Office Action Summary	Application No. 10/521,914	Applicant(s) MAZDA ET AL.	
	Examiner Jerry Cumberledge	Art Unit 3733

DETAILED ACTION

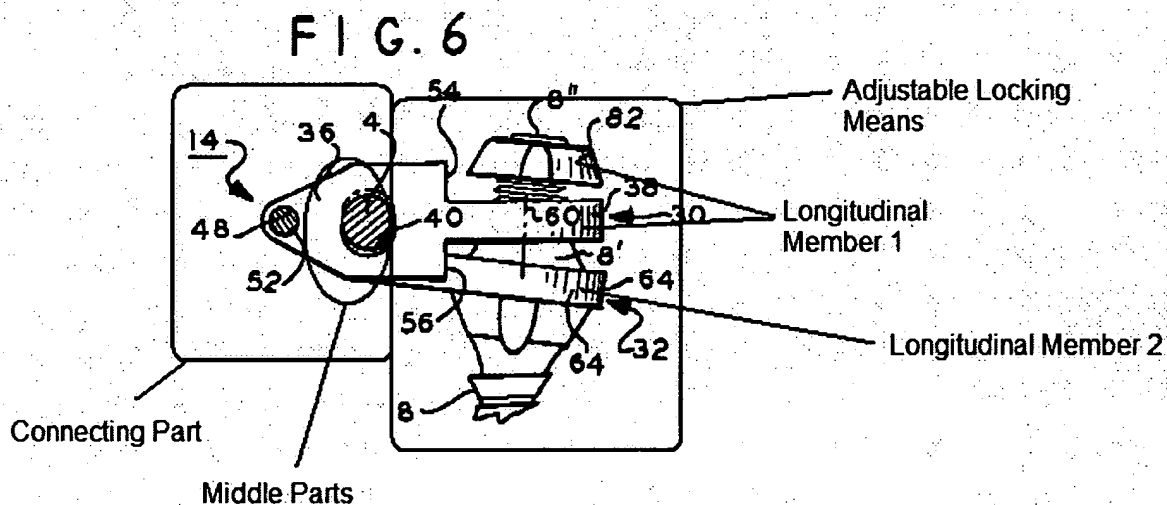
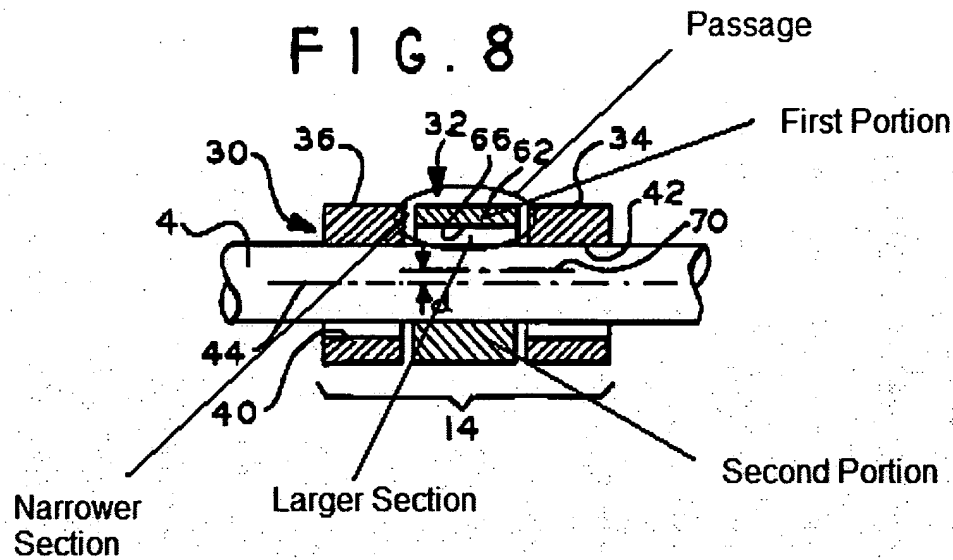
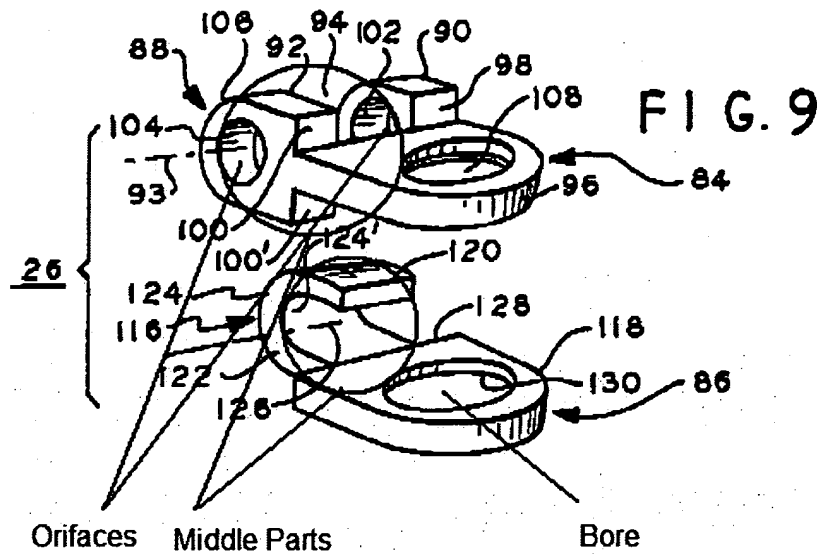
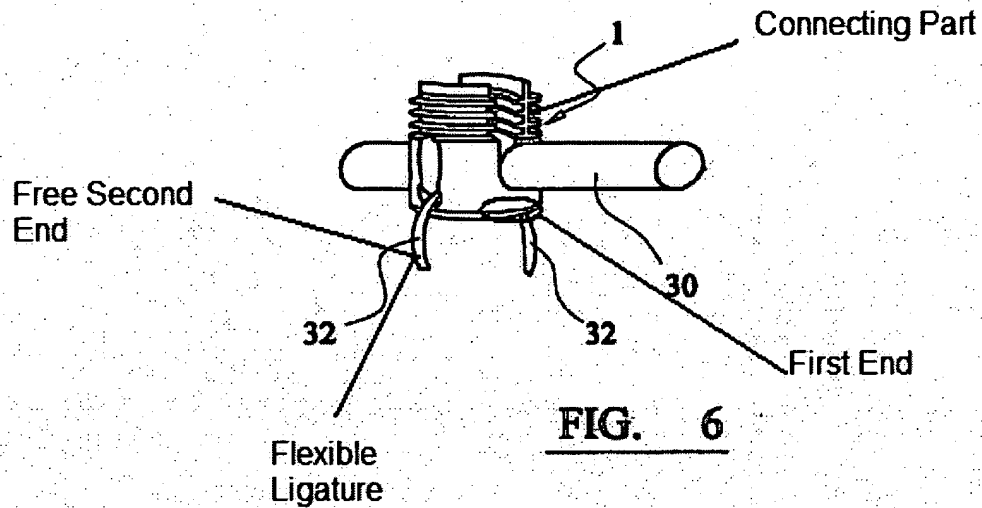
Fiz discloses a vertebral fixing system (Fig. 6 below) that is capable of mounting on a vertebra of the spine to connect it to a rod. The pedicle screw 8 (Fig. 6 below) is capable of mounting the system onto the spine. The system is capable of being placed on the spine in such a way that it would be in the vicinity of a posterior wall of a vertebra. The system comprises a connecting part (Fig. 6 below) capable of facing a rib and/or transverse process and capable of being connected to a rod. Fiz further discloses adjustable locking means (Fig. 6 below) fastened to the connecting part. The connecting part has a passage (as seen in cross section, Fig. 8 below) facing the rod. The adjustable locking means are capable of fixing the rod in place. The connecting part comprises two longitudinal members (Fig. 6 below), whose first ends are connected together and the members may pivot relative to each other. The middle parts (Figs. 6 and 9) of their two facing faces are capable of bearing on respective opposite sides of the rod. The adjustable locking means are capable of driving the second ends of the longitudinal members forcibly towards each other and to fix them in position relative to each other so that the two members form a clamp and grip the rod. This also allows the connecting part to be fixed in position relative to the rod. Fiz further discloses the second ends of the two longitudinal members having a bore in one and a thread in the other, so that a screw may be passed through the bore and screwed into the thread to

form the adjustable locking means. The second ends of the longitudinal members have facing each other, a bore in one (Fig. 9 below) and a thread in another. Considering the nut 82 (Fig. 6 below) as part of the longitudinal member, the longitudinal member then has a threaded portion. A screw can then be passed through the bore into the thread and form the adjustable locking means. At least one of the middle parts of the two facing faces has a first portion (Fig. 8) through which the passage passes and a second portion capable of bearing against the rod (Fig. 8). The passage extends between two orifices in the connecting part (Fig. 9 below). The passage is extended between the two orifices, even though it does not span the entire distance between them. The passage has a section that decreases from one orifice to the other (Fig. 8 below), which enables the passage to exert a progressing pressure on the ligature and press it against the rod.

Fiz does not disclose a ligature with a first end attached to the connecting part and a second free end.
